Work Instruction of Elastomer Replacement with Spring Contact

- Flow Chart of Elastomer Replacement
- Note: ESD wristlet is a must when touching components, Finger cot is a must when touching display, golden pads and spring contact.

Elastomer

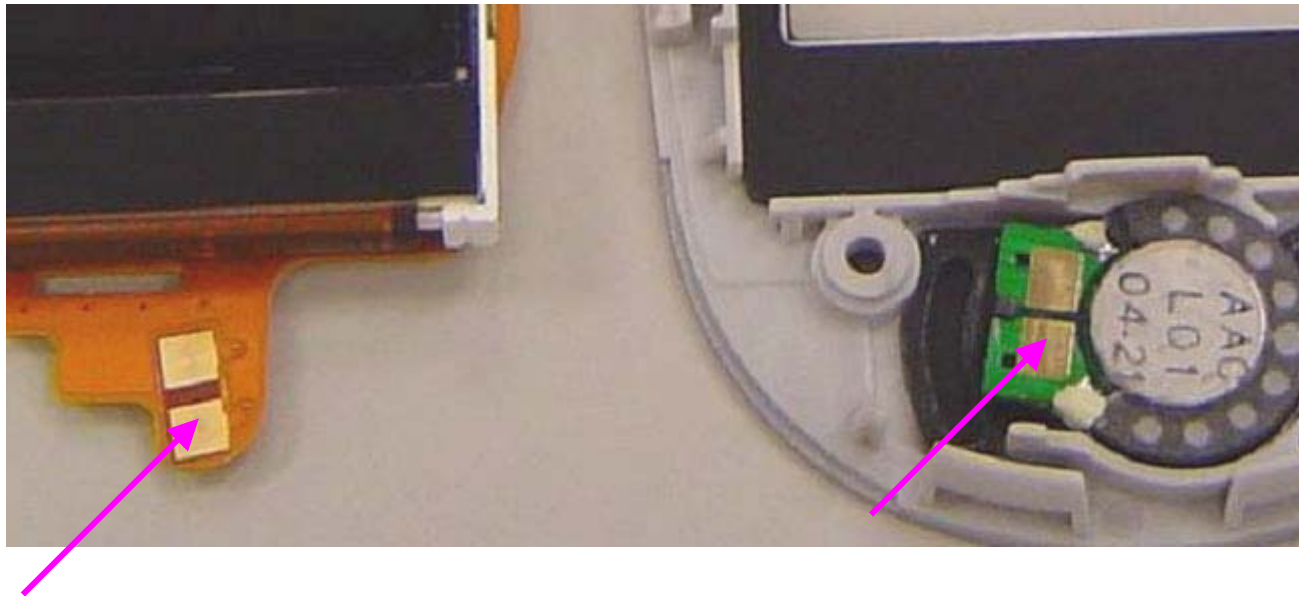
- Take off the 4 screw covers and unfix the flip screws
- Take off the flip cover, chassis, snubber, camera cover and camera
- Take off the LCD model together with flex cable
- Remove and discard the 3987819M02 Elastomer

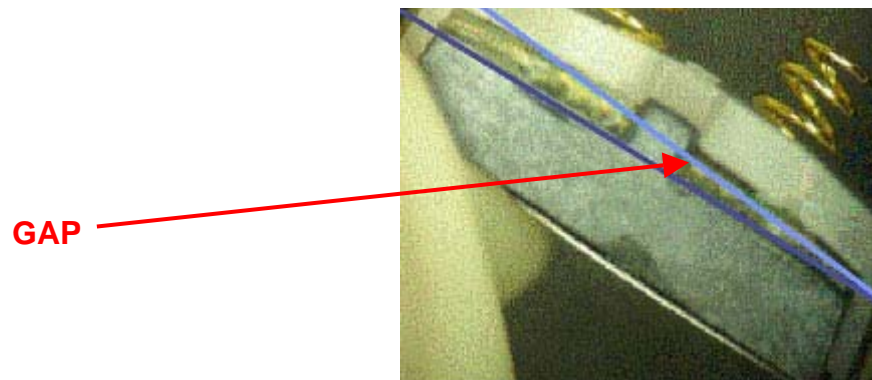
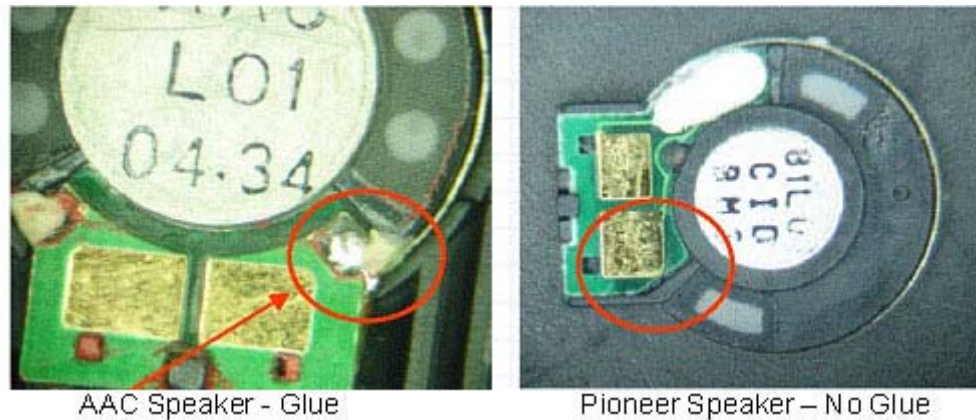
- There is a potential alignment issue present when attaching the L03 Spring Contact to some AAC Speakers due to variance in the height of the glue. See images below.
- If this issue is observed, the AAC Speaker should be replaced to allow proper mating with the new Spring Contacts.
